PONTIAC

Service Craftsman News

NO. 1 S-279

JANUARY, 1956

Fig. 1 Early and Late Type Hub and Piston

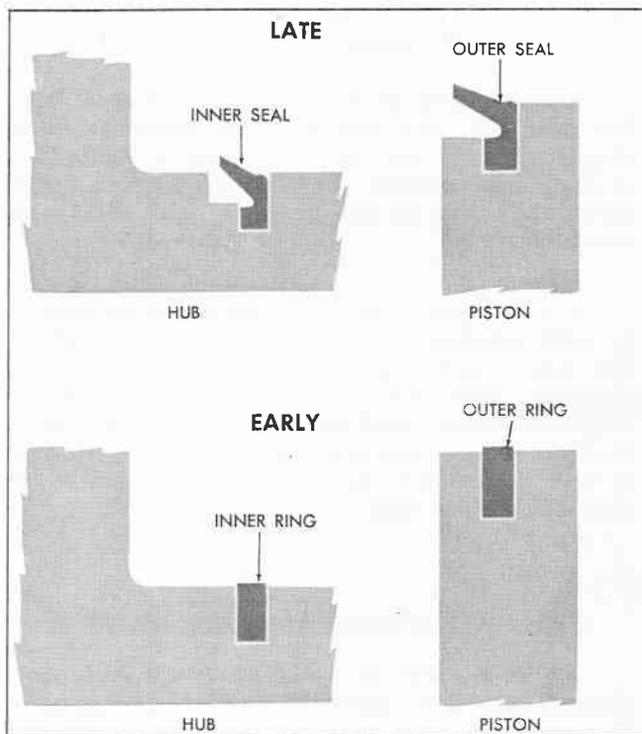
The inner and outer overrun clutch piston seals, neutral clutch piston seals, and reverse clutch piston seals are being changed from metal rings to composition rubber lip type. To accommodate the new seals it was necessary to redesign the seal grooves for both the inner and outer seals. These changes affect service as follows:

1. Overrun Clutch-- The new seals for the overrun clutch piston are now in production. In conjunction with the use of new seals, a new front pump assembly and overrun clutch piston assembly went into production. The difference in design of the seal grooves in these parts can be seen in Fig. 1.

2. Reverse Clutch-- The new seals for the reverse clutch piston are now in production along with a new rear pump (to accommodate the inner seal) and a new clutch piston (to accommodate the outer seal). The seal grooves in the early and late hubs are shown in Fig. 1. The ring grooves in the early and late reverse clutch pistons are very similar and both look like the late type in Fig. 1. The only sure identification of the early and late reverse clutch pistons is to test the fit of the metal oil ring in the groove. The metal ring will not fit in the groove designed for the rubber seal since this groove is slightly narrower.

3. Neutral Clutch-- The new seals for the neutral clutch will go into production in the near future. Along with the change in seals a new case center support and neutral clutch piston will be required in production. The difference in design of the seal grooves can be seen in Fig. 1. Also required is a new neutral clutch drum (Fig.2).

In each clutch all parts must be the same type. For example: If a late type front pump having the step type groove for the rubber seal is installed in an early transmission, the late type overrun clutch piston and rubber lip type inner and outer seals must also be installed.

Fig. 3 Checking Rear Clutch Apply Oil Passage

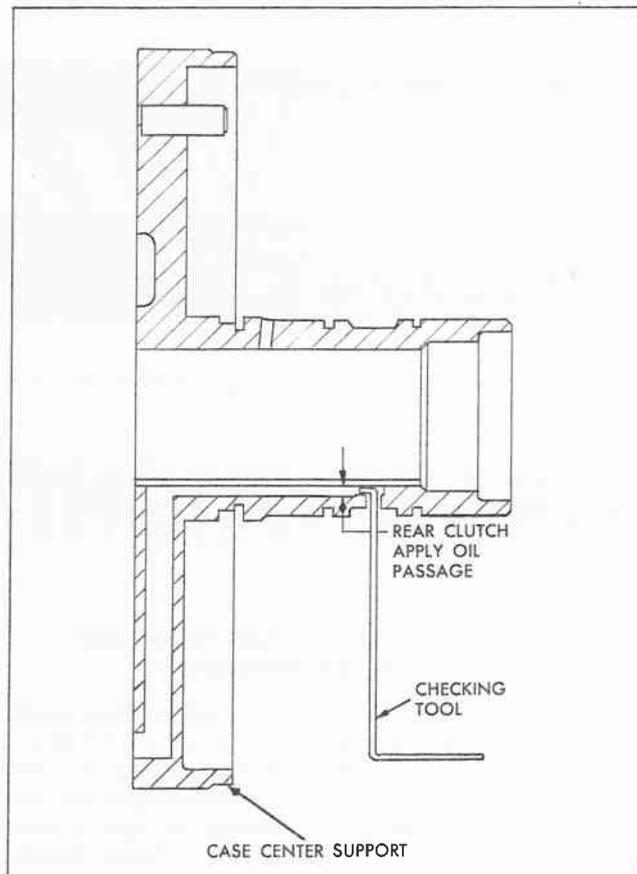
The rear clutch apply oil passage in the case center support has been enlarged to obtain an improved 2-3 shift. This passage should always be checked before the case center support assembly is put into a transmission, to make certain the improved part is used.

The special tool (.068" gauge) which was furnished attached to News Flash 55-39 should be inserted into the rear clutch apply oil passage as shown in Fig. 3. If the tool will enter the passage, the support can be used. If the tool will not go into the passage, the support should be replaced.

Fig. 4 Comparison of Early and Late Type Rear Main Bearing

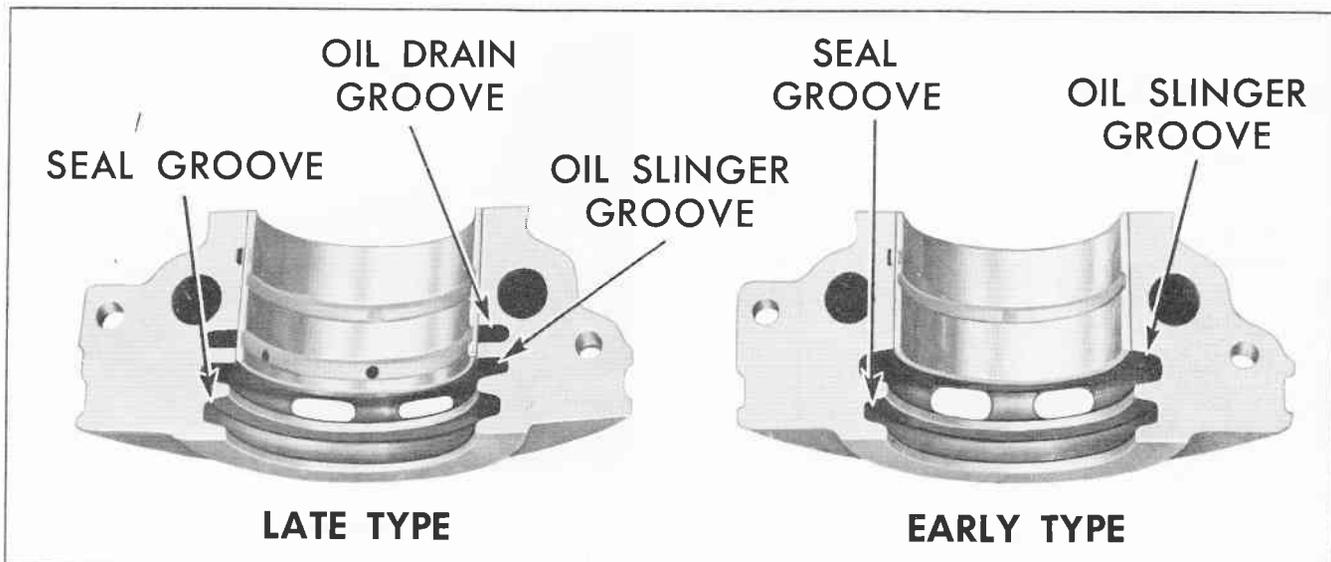
Fig. 4 illustrates the new rear main bearing design now being used to reduce the possibility of crankshaft rear main oil leaks. As shown in the illustration a groove and three oil drain holes are now incorporated in the bearing shell. These holes index with a machined oil drain groove in the main bearing cap and engine block. The new design allows oil drainage from the crankshaft journal and thereby eliminates oil getting to the packing seal under normal operating conditions. The packing seal is required for acceleration of the car or steep up hill driving.

Engines built on or after January 3, 1956 have the new type rear bearing shells, however, a number of engines were built after December 16, 1955 with the grooves machined in the block and cap but with the first type bearing shells installed. This was done because new shells were not available. If leaks are encountered on engines having the new groove and first type bearing shells, the second type shells may be installed.

When installing the new type shells it will be noted that the upper and lower shells are not interchangeable due to a difference in tang location.

The new bearing shells are released under package number 522825 (one upper and one lower) and are available as a zone warehouse item.

Fig. 5 Rochester 4-Jet throttle Body To Bowl Gasket

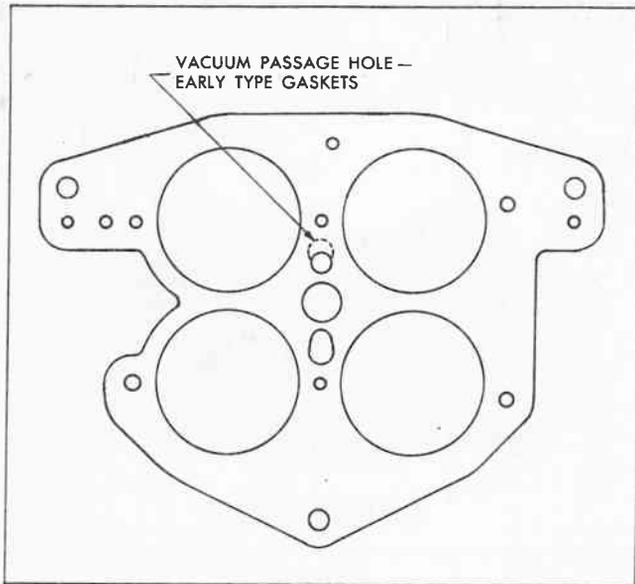
Engine stalling during warm up on cars equipped with the Rochester 4-Jet Carburetor may be due to a leak in the choke piston vacuum passage. A leak in the passage reduces the effect of engine vacuum in opening the choke thereby allowing engine to "load-up." Investigation of cases of this nature indicates that the usual cause of the condition is a leak at the carburetor throttle body to bowl gasket. The gasket originally used was shaped in such a manner that it could cause a leak between the vacuum passage and one of the secondary throats.

A new gasket is now being used in production to eliminate the possibility of a leak. The new gasket is available under part number 7009762 through the zone warehouse. All future carburetor gasket and repair kits will contain the new gasket.

The new gasket is illustrated in Fig. 5. The dotted line on the illustration shows the outline of the vacuum passage hole on early type gaskets.

To test for a choke vacuum leak, remove the choke housing to manifold pipe and check the vacuum at the choke housing. If vacuum is less than 10 inches, improper choke action will result. Replace the first type gasket with the 7009762 gasket and recheck choke vacuum to be certain condition is corrected. When gasket is being installed inspect upper

Fig. 6 Service and Production Pinion Bearing Spacers

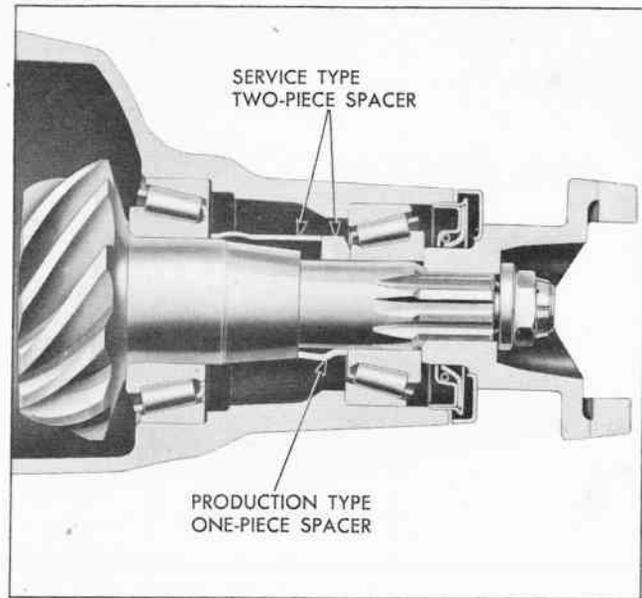
In early 1955 production a two piece differential pinion bearing spacer was used. In later 1955 and 1956 production a one piece spacer was used. However, the two piece spacer was retained for service for all 1955 and 1956 models (Fig. 6 illustrates the one piece production type spacer and the two piece service type).
